## SPECIFICATION NOTICE LT1512

September 1998

The **LT®1512** is now available in the **GN** package (16-pin narrow SSOP). Functional changes are described below. All other specifications remain unchanged. For complete specifications, typical performance characteristics and applications information, please see the **LT1512** data sheet.

## PACKAGE/ORDER INFORMATION

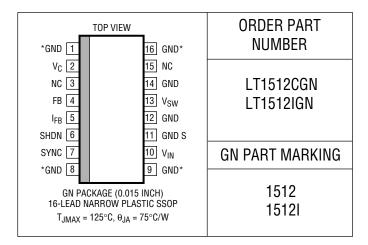
\* The four corner pins (1, 8, 9, 16) are fused to the internal leadframe to lower thermal resistance. These pins should be connected to copper plane areas on the board for proper heat sinking. The  $\theta_{JA}$  value is preliminary.

The GN package has the Shutdown and Synchronization (S/S) functions brought out to separate pins. The functions remain the same.

**SHDN (Pin 6):** The shutdown pin will default to a high ON state when floated. A logic state will shut down the charger to a micropower state. The shutdown pin is logic level compatible but can be tied to  $V_{\text{IN}}$  if desired.

**SYNC (Pin 7):** The SYNC pin can be used to synchronize the switching frequency of the device. Driving the SYNC pin with a continuous switching logic signal of 600kHz to 800kHz will synchronize switching frequency to the external signal. If the synchronization function is not used, the SYNC pin should be grounded.
